**From:** Karen Beare [REDACTED]  
**Sent:** 04 May 2019 22:08  
**To:** Thuair, Charles [REDACTED]  
**Cc:** Bob Warnock [REDACTED]; Harley Atkinson [REDACTED]; Kathy Lambie [REDACTED]; John Kennedy [REDACTED]; Steve Barber [REDACTED]; Susan Rose [REDACTED]; Michael Hammerson [REDACTED]; Nicola Mayhew [REDACTED]; Vicki Harding [REDACTED]  
**Subject:** Re: 2019/0704/P - SUDS and drainage - 53 Fitzroy Park - Condition 13

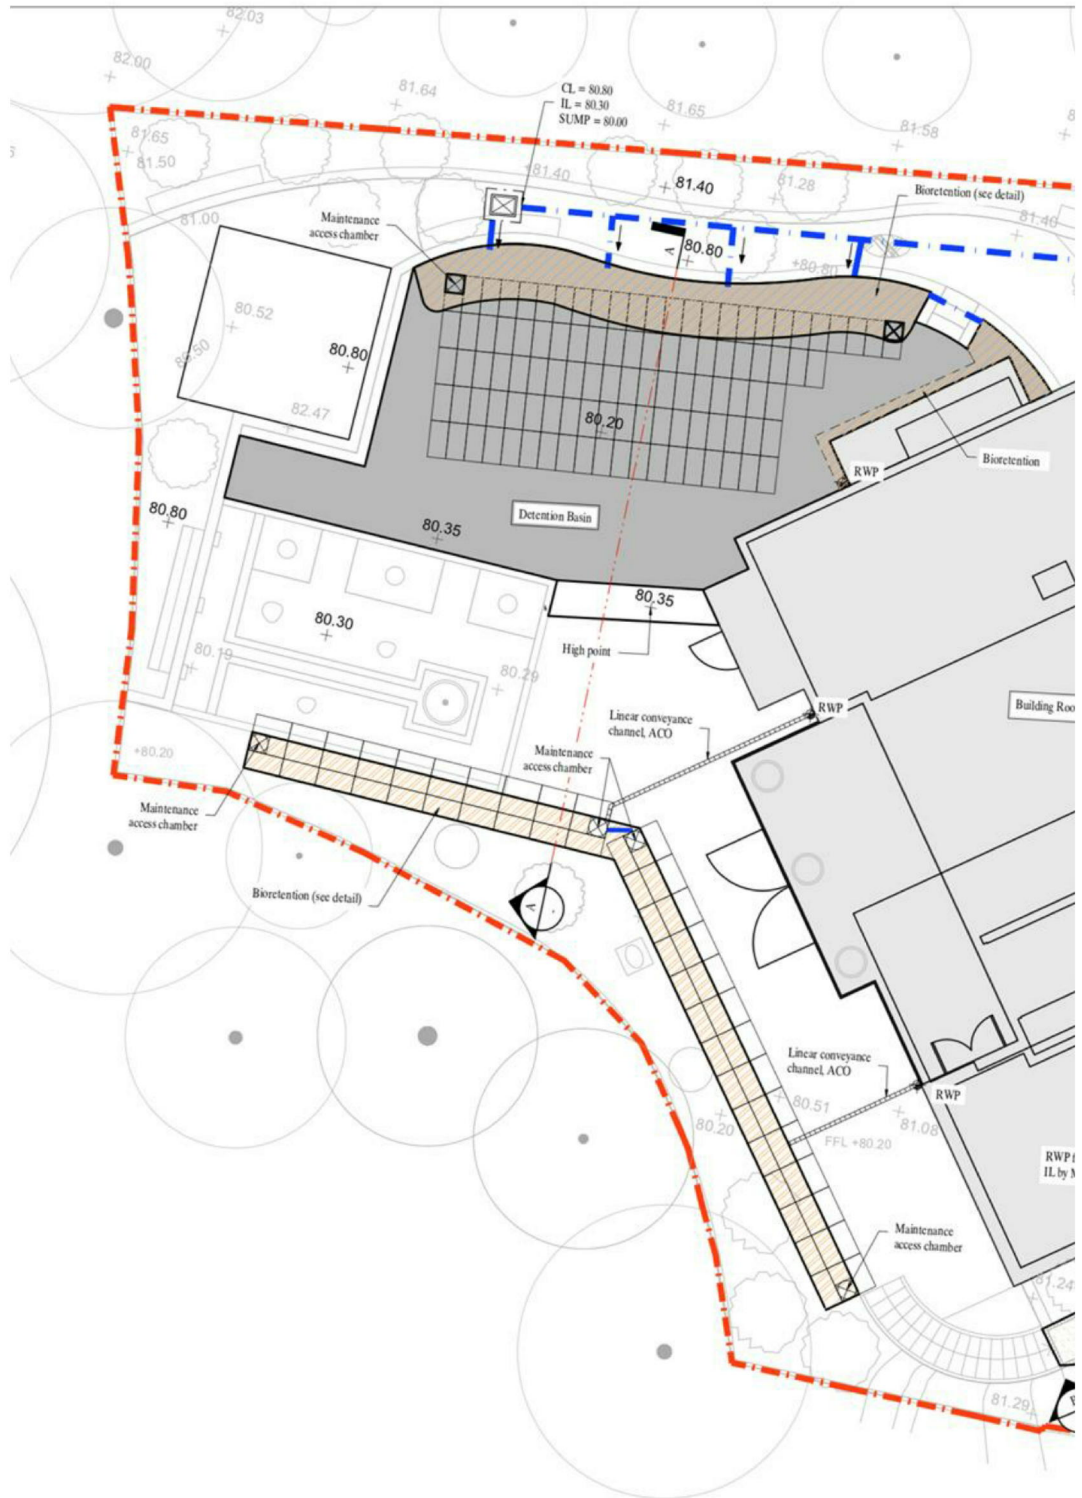
We are told the SUDs will be designed using the lowest obtained f value, assuming of course a trial pit was actually done in the correct area... It would be perverse if only 1 out of 10 Trial Pits were to be relied on to design a detention basin area of almost 120m<sup>2</sup>, but in fact that is exactly what has happened. This is also true of Catchment 3 where TP5 is the only trial pit in the correct location..

Only TP3 is anywhere near this extensive SUDs for Catchment 2. In fact, when you overlay the site investigation with the proposed solution it is almost outside the footprint of the proposed detention basin!

We also note the infiltration rates at TP3 are recorded as follows for two tests at each location:

TP3: Test One: **3.79E-05 m/sec**

TP3: Test Two: **1.81E-05 m/sec**

The first observation is that TP3 has a significant anomaly in the results between the two tests and given the significance of its location should have been re-tested.

The second observation is that in the narrative we are told the actual bioretention location for Catchment 2 is equal to  $8.21 \times 10^{-6}$  m/s - which is quite different to the actual results for TP3.

It would appear the drainage design does not take account of the real values in the actual location of the SUDs, which as shown above suggest much slower rates of infiltration than being suggested.
